RESPONSE TO BRISBANE CITY COUNCIL'S FURTHER ADVICE – S.35 OF THE DA RULES

DEVELOPMENT PERMIT FOR MATERIAL CHANGE OF USE FOR MULTIPLE DWELLING (88 UNITS), SHORT-TERM ACCOMMODATION AND CENTRE ACTIVITIES (SHOP AND FOOD AND DRINK OUTLET), DEVELOPMENT PERMIT FOR MATERIAL CHANGE OF USE WITHIN THE FLOOD OVERLAY, AND DEVELOPMENT PERMIT FOR CARRYING OUT BUILDING WORK WITHIN THE FLOOD OVERLAY, OVER LAND AT 22-24 SYLVAN ROAD, TOOWONG (LOT 2 ON RP69784 AND LOT 1 RP196515)

COUNCIL REFERENCE: A006913504

Figure 1: Plan view of privacy screening to balcony within 4.5m of the side boundary (MAS, 2026)

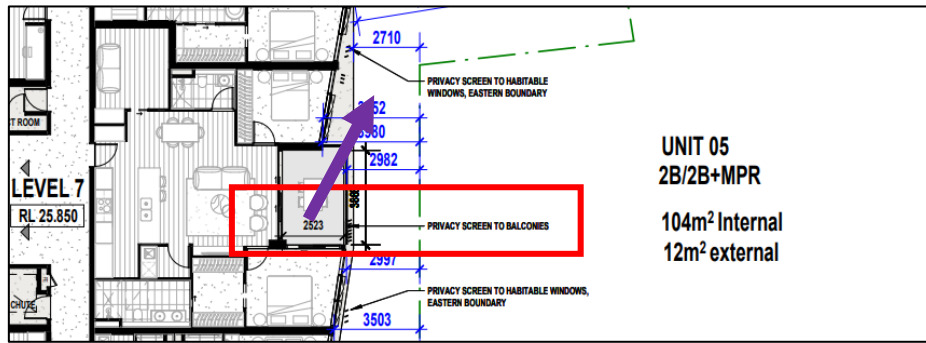
While the revised design includes amended setbacks, the privacy concerns identified in the Information Request have not been adequately addressed. Additional side-facing balconies have been introduced, and eastern setbacks have been reduced to 3m, where setbacks were previously 4.2m-4.5m. Provide the following:

- a) *Screening to all side-facing balconies located less than 4.5m from a boundary.*
- b) *Revised balustrade treatments capable of improving privacy outcomes, such as battened, perforated or comparable privacy screens.*
- c) *Details of any privacy and sun-shading measures, including drop-down blinds where proposed.*
- d) *Where habitable rooms or balconies are located within 4.5m of the eastern boundary and are not screened by solid walls, demonstrate how the design will achieve the privacy outcomes of the City Plan. Integrated privacy screening measures may be required.*

In respect of item a), the proposed development has only one side-facing balcony on each level above Level 5 which has a setback of less than 4.5m from the eastern boundary. This balcony, which is centrally located on the eastern elevation, has been provided with both vertical and horizontal screening (refer to **Figure 1** for a plan view and **Figure 2** for the elevation view).

The position of the screening, together with the balustrade treatments and the recessing of the facade to the north of the balcony, provide a design which encourages the outlook from the balcony to the north, along the side boundary rather than across it, as shown by the purple arrow in **Figure 1**. This outcome appropriately addresses the nature of the interface, and the desired privacy outcome.

Figure 8: Podium section A (left) and render (right), which shows the projecting blade elements (MAS, 2026)

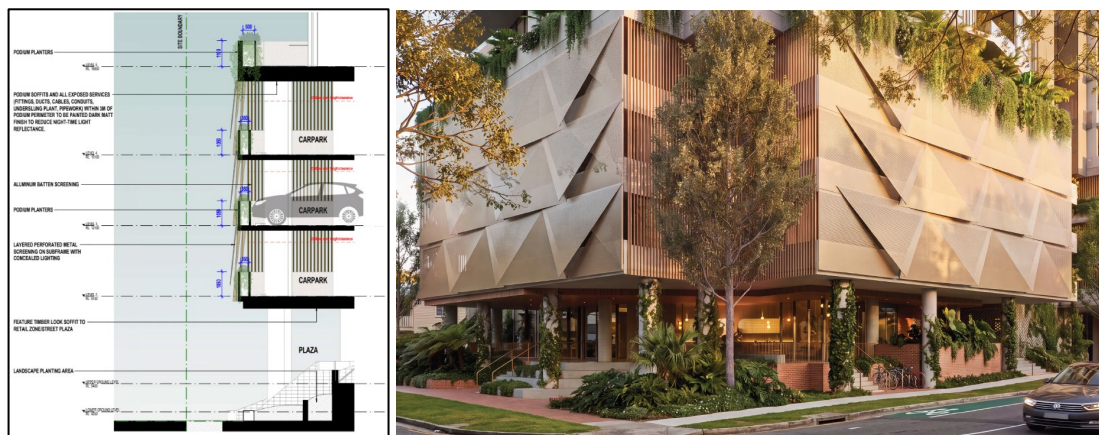
- a) Plans demonstrating that all proposed podium planters can be accommodated without impacting podium parking.
- b) Increased façade articulation and depth capable of creating shadowing and reducing perceived building bulk.
- c) Clarification of the podium section locations and consistency with the floor plans.
- d) Removal of the podium roof structure over the nominated deep planting area, as deep planting must be open to the sky.

In respect of item b), the podium facades have been refined, with the elevations and sections updated to accurately show the extent of articulation and shadowing on the podium façade. The podium façade features a faceted, blade-like façade treatment, which projects from the façade plane to introduce depth, cast shadows and reduce the perceived bulk of the podium.

The arrangement and depth of the blade elements are further illustrated in **Figure 9**, which demonstrates how the façade treatment projects beyond the primary podium wall and creates a more articulated and visually recessive built form. This treatment is complemented by the integrated landscaping and screening shown on the revised architectural plans.

Figure 11: Sliding doors shown on balcony (Unit Type 6 shown) (MAS, 2026)

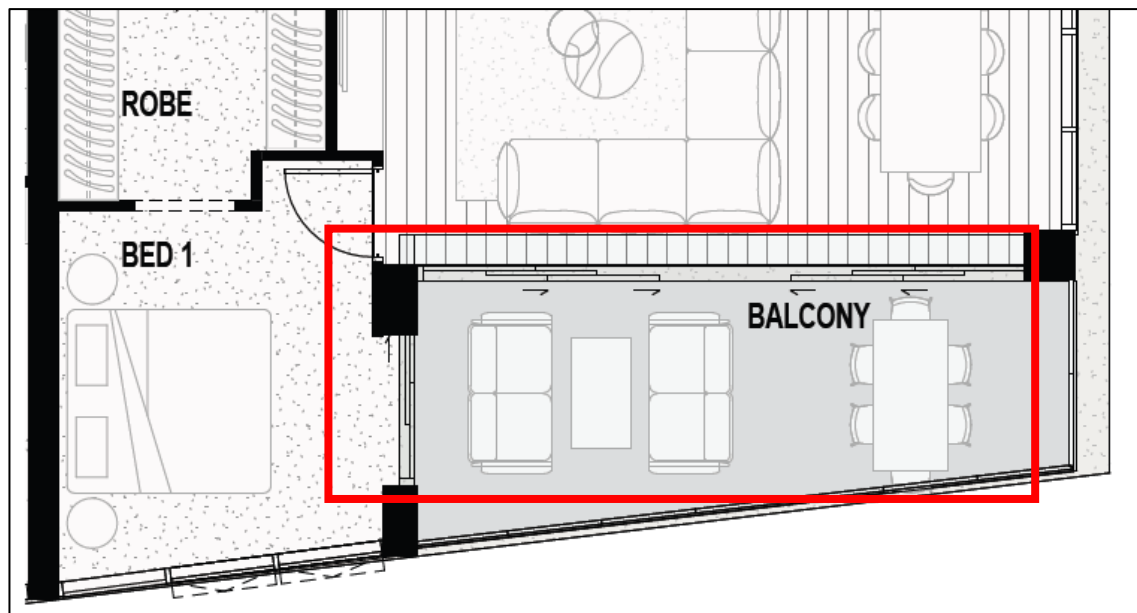
- Louvre windows to habitable rooms.*
- Sliding screen doors where sliding doors are proposed to facilitate natural ventilation.*
- Additional solid wall elements and more substantial balustrade treatments to the western elevation to reduce reliance on glazing.*
- Details and dimensions of all slab projections, awnings and shading devices proposed to the northern and eastern elevations.*
- Further justification demonstrating how the eastern and western façades achieve the outcomes sought by the Buildings that Breathe guidelines.*

The detailed screening treatment to sliding doors will be integrated with the balcony design to provide solar protection and privacy without unnecessarily restricting the operation of the doors or the flow of air (refer to **Figure 12**).

Figure 14: Buildings that Breathe – Natural Air and Ventilation Aspects (MAS, 2026)

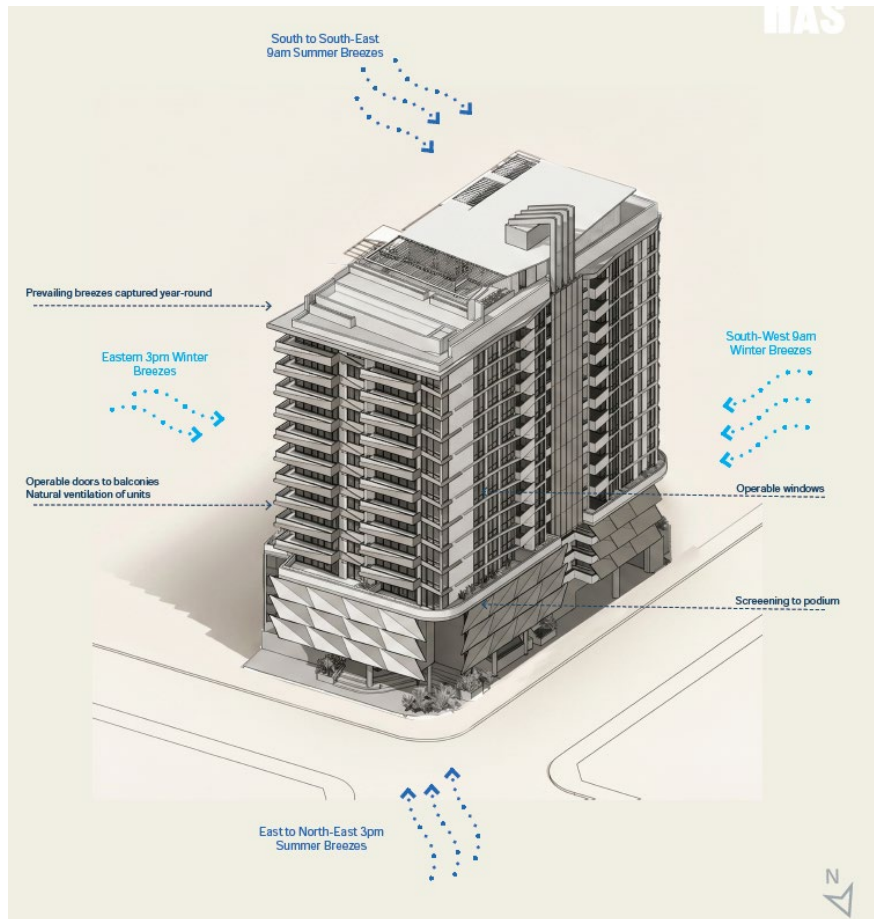
The eastern and western elevations continue to contain a high proportion of glazing, with limited external shading and opportunities for natural ventilation. Provide the following:

Note: Council remains concerned that the eastern elevation is overly glazed and lacks sufficient shading elements to respond to its orientation. While screening outcomes on the western elevation have improved, the façade continues to exhibit a high proportion of glazing.

These measures, together with the orientation of the apartment layouts and provision of external living areas, support natural ventilation, daylight access and passive solar protection. Overall, the eastern and western façades provide an appropriate subtropical design response having regard to the site's orientation and surrounding context. **Figure 15** below identifies how the development responds to the Buildings that Breathe matter with respect to natural air and ventilation.

Figure 15: Revised Floor Level Outcome Above Deep Planting (South West Portion) – Proposed (Left) and Revised (Right) (MAS, 2026)

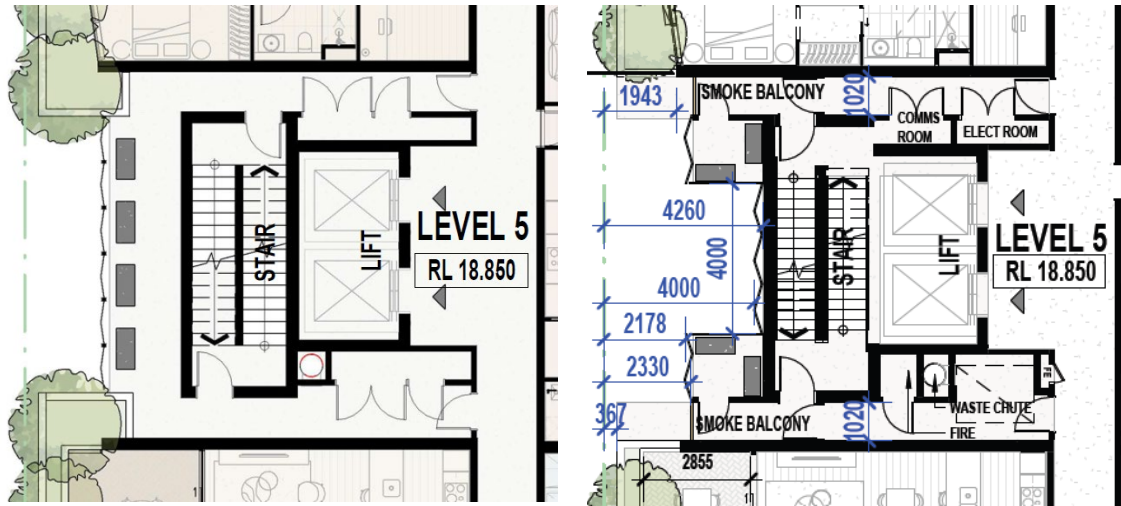
The proposal does not adequately demonstrate compliance with PO13h, PO24h, PO25a and PO56 of the Centre or mixed use code. The proposed deep planting area remains substantially below the minimum 176m² required and is fragmented into small planting areas that are unlikely to support the establishment of mature subtropical canopy trees.

- a) Amended landscape and architectural plans demonstrating an increase of contiguous deep planting capable of supporting mature subtropical canopy trees.*
- b) Details demonstrating that the proposed deep planting areas provide sufficient soil volume and dimensions to achieve long-term canopy growth outcomes.*
- c) Revised plans confirming that nominated deep planting areas are open to the sky and are not constrained by buildings, structures or podium elements.*

Regarding the south western side deep planting area, the Level 5 Floor Levels and above have been amended which have created 4m x 4m dimensions which are fully open to the sky. As shown in **Figure 16** below. This has been achieved by reconfiguring the plant and equipment spaces on each level. This assists in creating a strong vertical break in the building that reinforces the ground level deep planting outcome.

Figure 20: Revised Swept Paths (Bitzios, 2026)

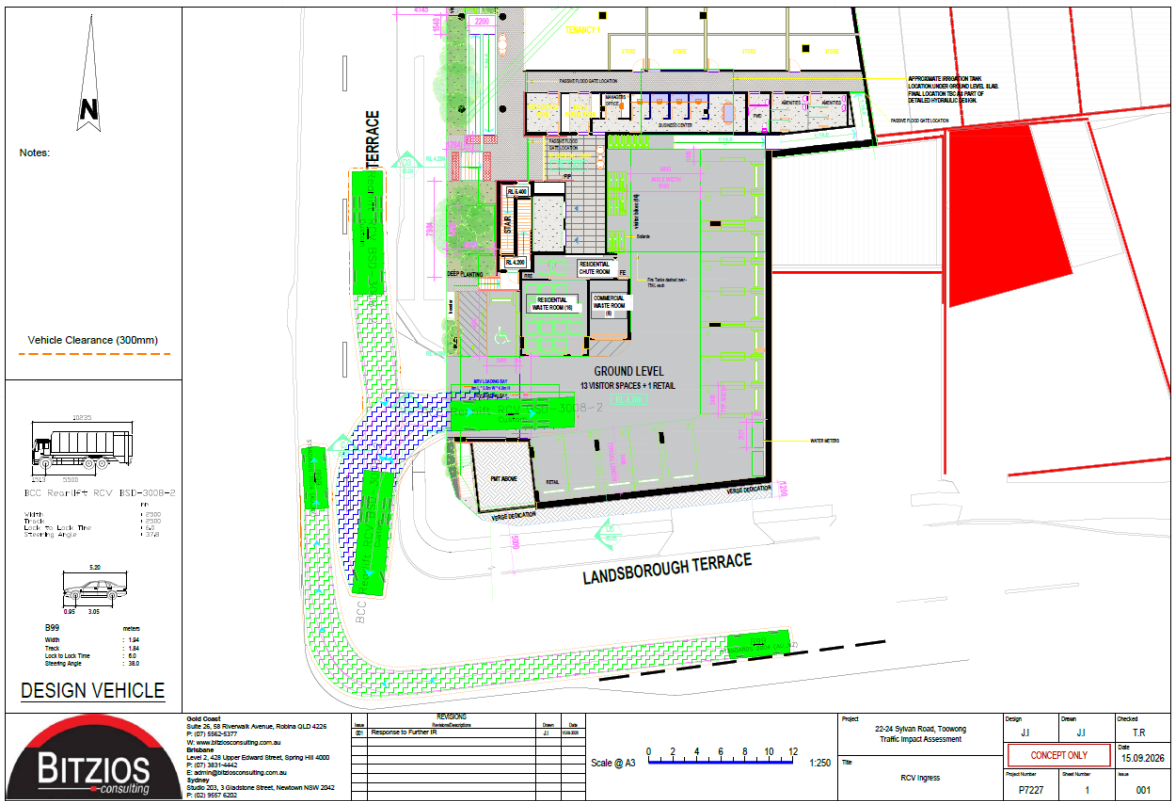
- Updated swept path plans demonstrating through-road clearances measured to the opposite kerb line. The assessment is to specifically address potential conflicts associated with the refuse collection vehicle egressing onto the opposite side of Landsborough Terrace near the adjoining intersection.
- Confirmation of the total loss of on-street parking spaces resulting from the removal and reinstatement of existing crossovers and the construction of the proposed new crossovers.
- An assessment of the impact of the development on existing on-street parking infrastructure, including parking signs, line-marking, taxi zones, loading zones, 1P parking areas and no-standing zones. Provide an on-street parking layout plan identifying all required signage and line-marking amendments.

In respect of item a), updated Refuse Collection Vehicle (RCV) swept paths have been

undertaken, retaining a minimum 3.0m clearance from the edge of the kerb on the western side of Landsborough Terrace to allow sufficient width for typical opposing traffic movements. The RCV is able to be wholly located on the site. An extract of the revised swept path is provided below in **Figure 18**.

Figure 18: New Internal Access Ramp – Ground Floor (MAS 2026)

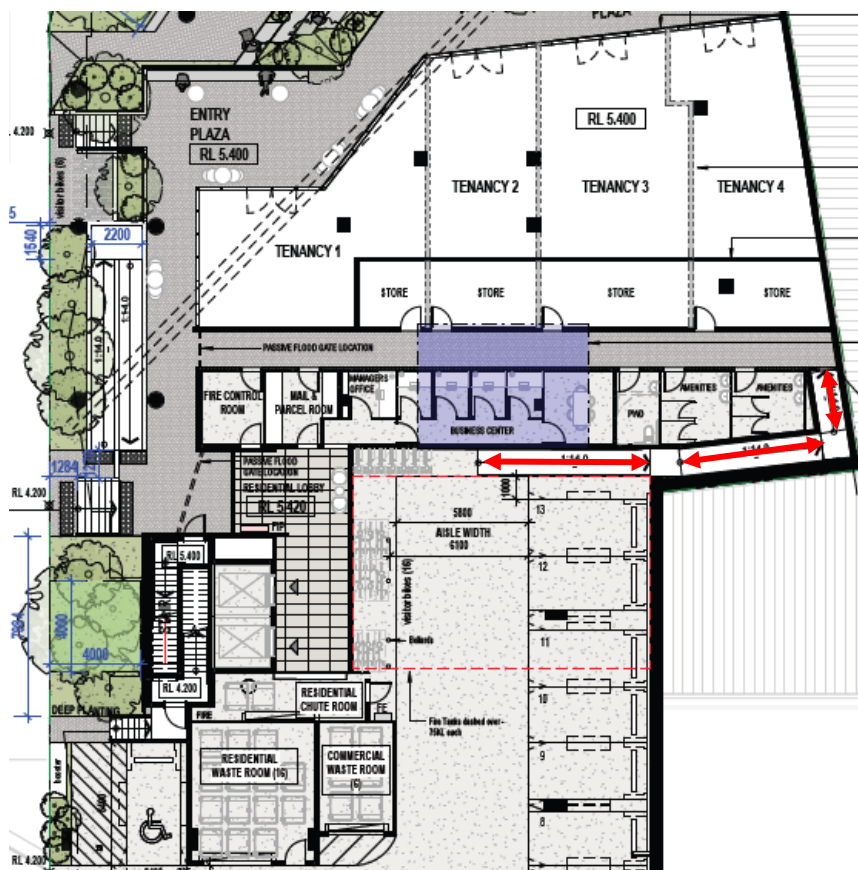
The proposed design does not demonstrate compliant pedestrian access between the ground floor parking areas and the lifts. Amend the plans to demonstrate suitable pedestrian access for:

- Transfer of retail waste, bulky waste and other large items between the retail tenancy, storage areas and foyer lifts.*
- Access between the basement and ground floor parking and bicycle parking areas and the lifts, including access for users of the PWD parking spaces.*

The Ground Floor Plan has been amended to include a new 1:14 gradient ramp within the space adjacent to car park 13. The new ramp provides an equitable pedestrian connection between

the retail tenancies, storage and refuse areas, and the Ground Level car parking. The revised arrangement facilitates the transfer of retail waste, bulky waste and other large items between these areas and the Ground Level foyer and lift access.

Figure 19: Ground level bicycle parking outlined in yellow (16 visitor spaces)

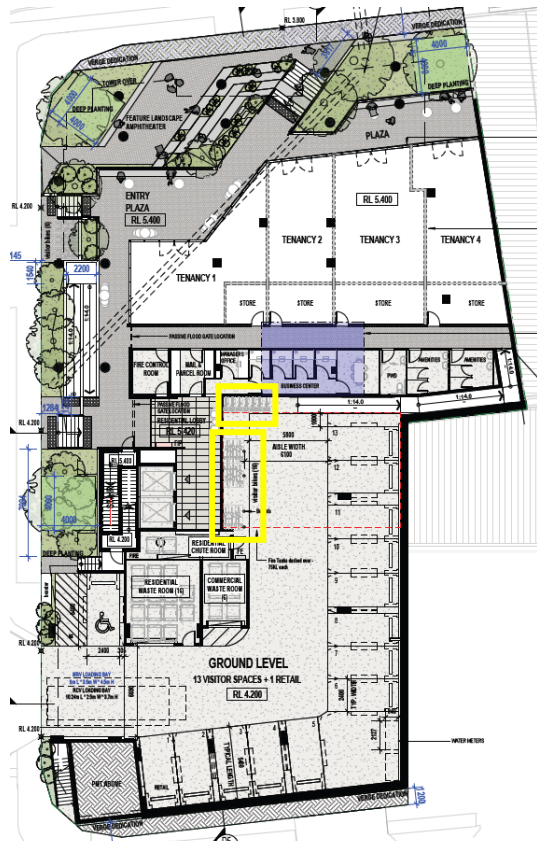
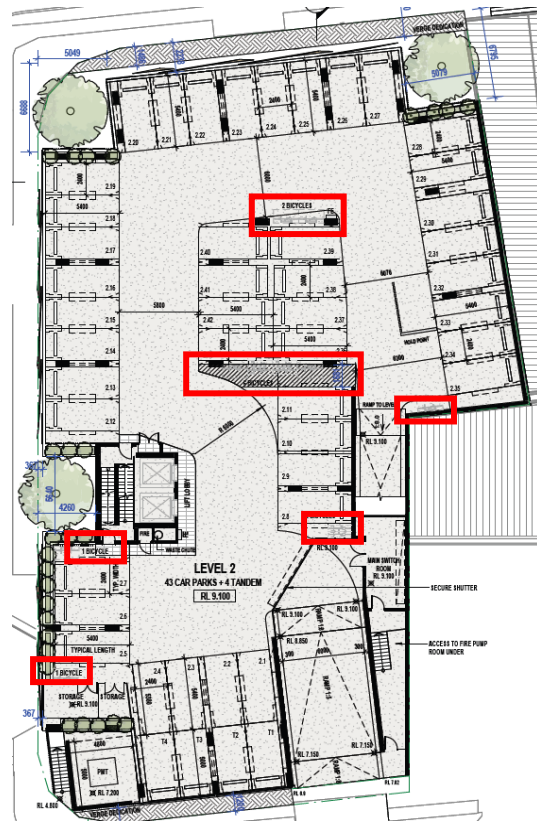
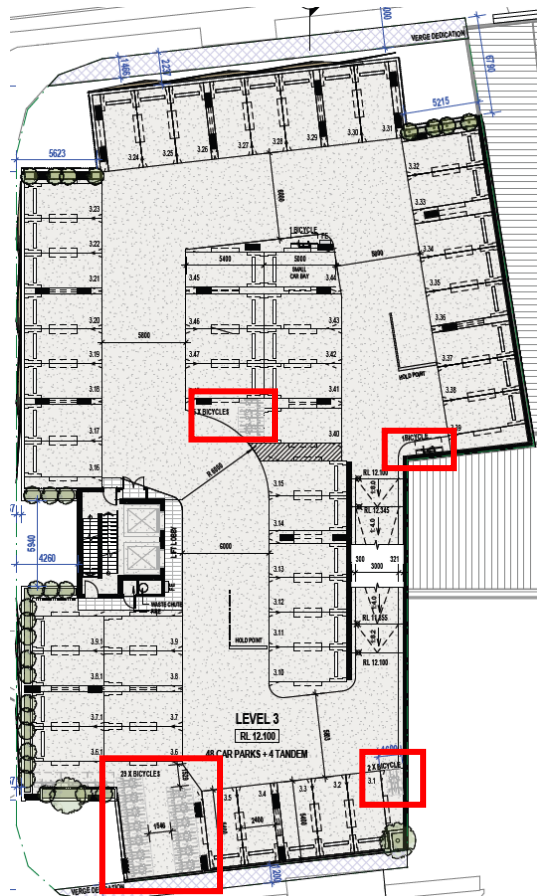
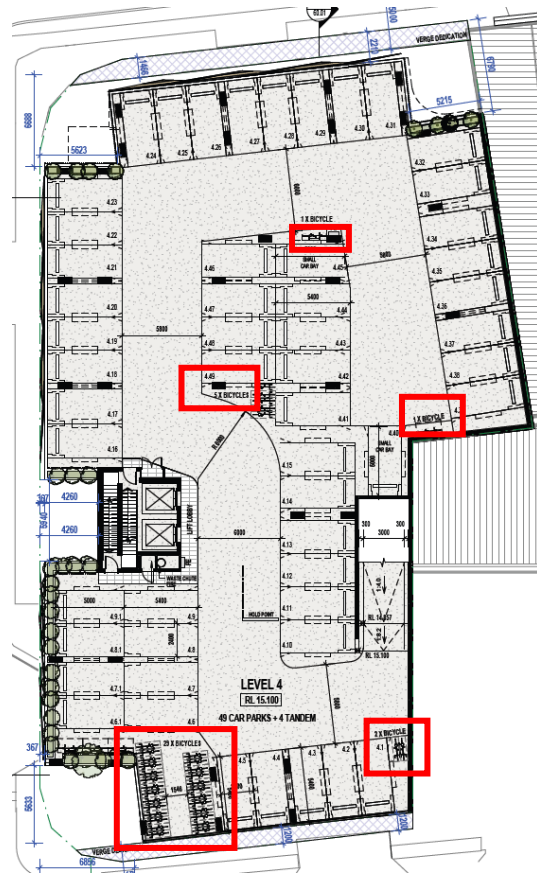
The six bike (vertical) parking spaces, adjacent to car spaces, 2.35; 3.39; 4.39, do not maintain the required minimum 1.50m aisle width and should be relocated.

The six bicycle parking spaces identified above have been relocation to locations which are provided with appropriate access, in accordance with AS2890.3 *Parking facilities, Part 3: Bicycle parking*. **Figure 24** to **Figure 27** below shows the revised outcome associated with the bicycle parking throughout the development.

Figure 23: New ramp on ground floor highlighted in red (MAS, 2026)

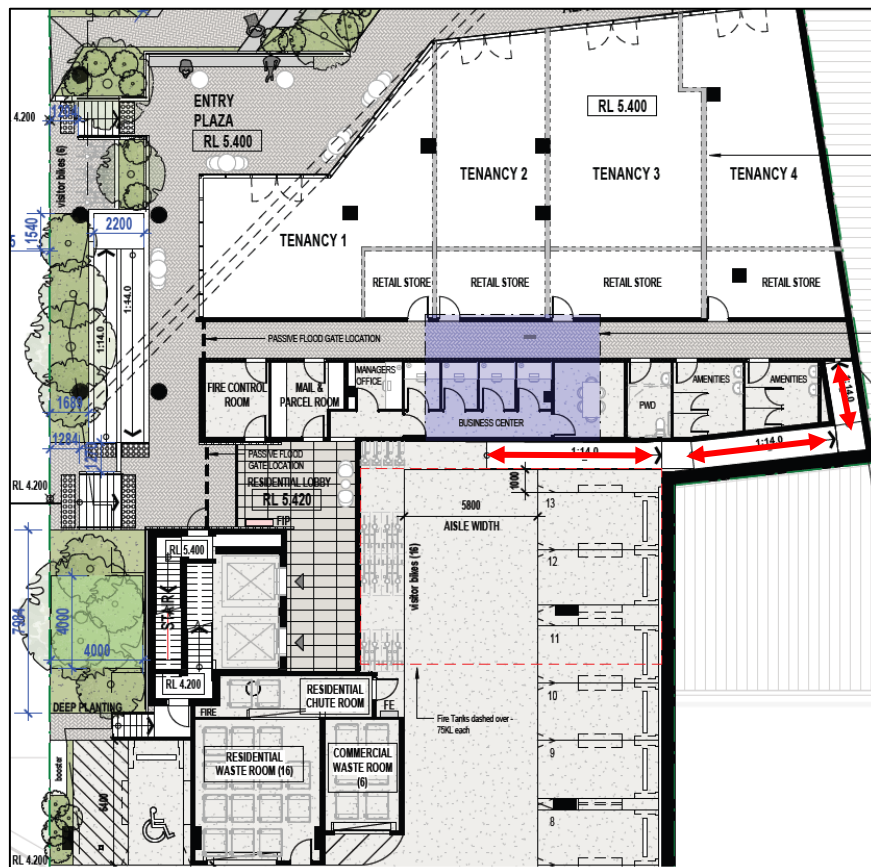
- a) *The transfer, storage and collection of bulky waste items, including a compliant access route between tenancy floors, lifts and waste storage areas. There is also no transfer route / ramp for the commercial waste to storage areas - only via stairs.*
- b) *The management, storage and disposal of problem wastes, including e-waste, batteries, cardboard, polystyrene, printer cartridges and unwanted clothing.*
- c) *Amend the Waste Management Plan and architectural drawings accordingly.*

A ramp has been provided between the tenancies and the waste storage areas on ground level (refer to **Figure 28**). This new ramp will allow convenient access from the retail tenancies to the waste storage areas.
